Project: LFUCG PSOC PH 2

Subject: Electrical Room 142 Ductless Split Cooling Unit

MPE REQUEST FOR PROPOSAL

SUBJECT: RFP 13 – Electrical Room 142 Ductless Split Cooling Unit

XME01

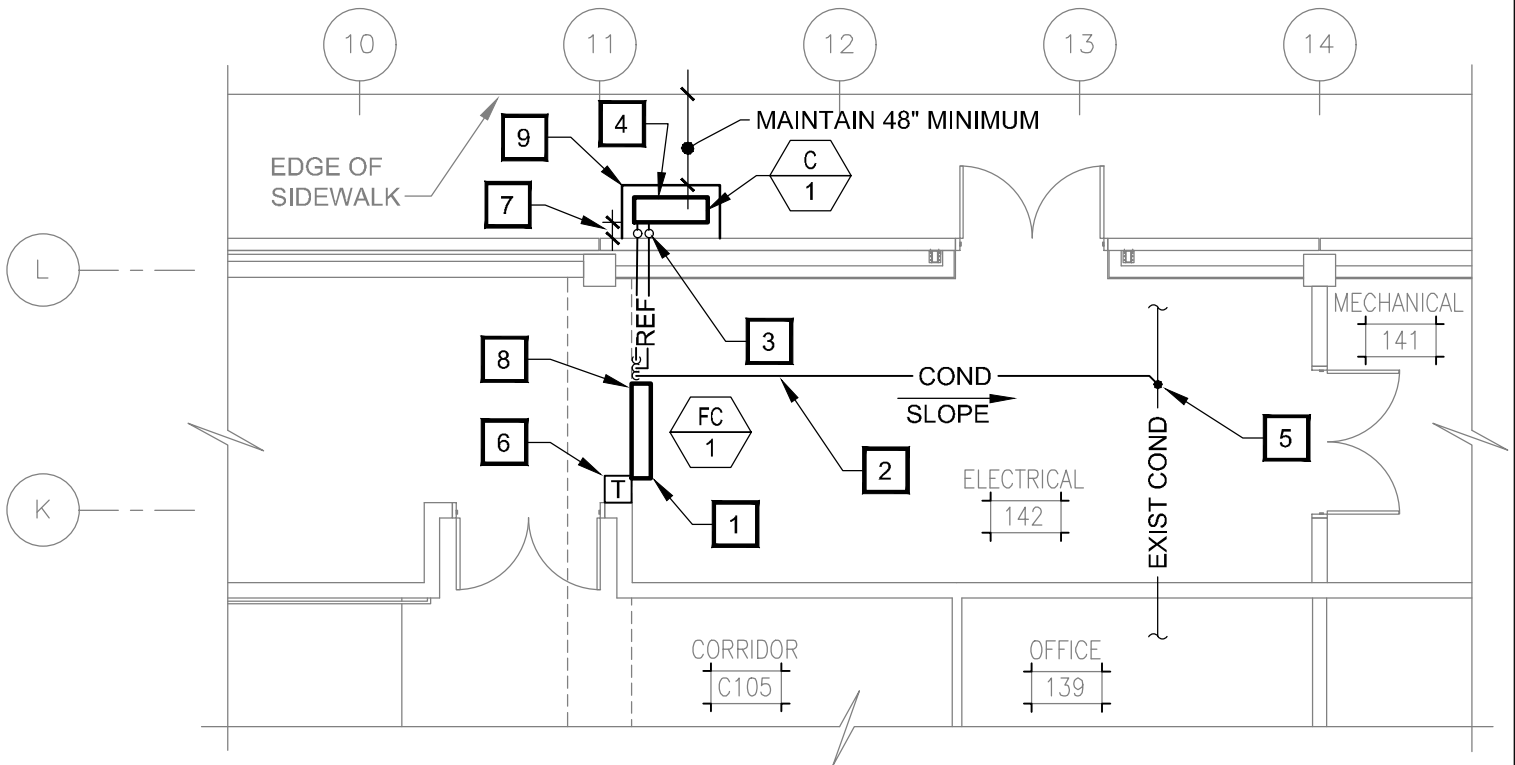
Since commissioning, Electrical Room 142 was found to be consistently warm (in the upper 70s) when outdoor air temperatures are above approximately 80 deg F. Marcum Engineering has reviewed records and the as-built conditions. The contribution to the high heat load is due to be the large UPS system which rejects 36,000 BTUH in lieu of the 18,000 BTUH allowed. The UPS system supports both Phase 1B and Phase 2 (911) electrical loads. The large cooling load required for the UPS will present additional problems in the winter as that VRV systems cannot support a heat recovery system that is predominately in heating mode with one zone requiring cooling. Therefore, the addition of VRV Fan Coils will not satisfy the cooling dominate load during the winter.

The solution is the addition of a 3 Ton cooling only unit. This unit will provide the cooling needed for the UPS during the winter and the additional cooling needed during the summer. A 3 Ton ductless split system can handle the localized heat gain from the UPS. Meanwhile, the heating and cooling of the space will continue to be supplied by the two (2) existing VRV units. This solution will maintain a room temperature of approximately 72 degrees F (as approved by LFUCG).

This RFP covers the following: addition of the cooling only system; connection of the system to an emergency powered circuit; and limited integration of the unit into the Building Management System.

Reference Drawings H1.1 and E1.3 and the attached Sketches XME01 and XME02. The Contractor shall provide a proposal for the following:

- Furnish HVAC equipment as indicated.
- Install HVAC system as indicated.
- Label and set thermostats as indicated.
- Install electrical power as indicated.
- Modify BMS HVAC controls and integrate Daikin remote controller as indicated on Sketch XME02.

1	MOUNT INDOOR UNIT AND REFRIGERANT PIPING ON SIDE OF EXISTING CONCRETE ROOF BEAM.
2	ROUTE CONDENSATE PIPING HIGH AS PRACTICAL. COORDINATE WITH EXISTING CONDITIONS.
3	ROUTE REFRIGERANT PIPING UP AND PENETRATE WALL AT BEAM ELEVATIONS. COORDINATE WITH EXISTING ELECTRICAL PANELS AND COMPONENTS.
4	SECURE OUTDOOR UNIT TO STAND AND SECURE STAND TO CONCRETE SIDEWALK WITH ANCHOR BOLTS.
5	CONNECT NEW 1" CONDENSATE PIPING TO EXISTING CONDENSATE PIPING. SLOPE DOWN FROM UNIT TO EXISTING. FIELD VERIFY EXISTING LOCATION.
6	INSTALL THERMOSTAT ABOVE EXISTING AND LABEL EACH RESPECTIVELY AS: "VRVD-142A/142B = HEATING & COOLING" AND "FC-1 = COOLING ONLY". THE CONTRACTOR SHALL CHANGE THE VRV SET-POINTS TO 74°F COOLING AND 65°F HEATING WITHIN THE DDC PROGRAMMING. THE CONTRACTOR SHALL SET THE COOLING ONLY THERMOSTAT FOR FC-1 TO 72°F OF YEAR AROUND OPERATION.
7	DO NOT EXCEED 8" UNLESS MANUFACTURER REQUIRES MORE CLEARANCE.

8	ELECTRICAL CONTRACTOR SHALL FURNISH AND INSTALL A NEW 2P20A BRANCH BREAKER IN THE AVAILABLE SPACE OF PANEL EA2 AND EXTEND 2-#12'S, #12 GRD. IN 1/2" CONDUIT TO C-1, FURNISH AND INSTALL A 2P30A NON-FUSED NEMA 3R DISCONNECT AND MAKE FINAL CONNECTION TO C-1 IN LIQUID TIGHT FLEXIBLE METAL CONDUIT. COORDINATE WITH MECHANICAL CONTRACTOR AND FURNISH AND INSTALL POWER CONNECTION BETWEEN OUTDOOR UNIT AND INDOOR UNIT.
9	EQUIPMENT STAND. SEE HVAC SCHEDULE.
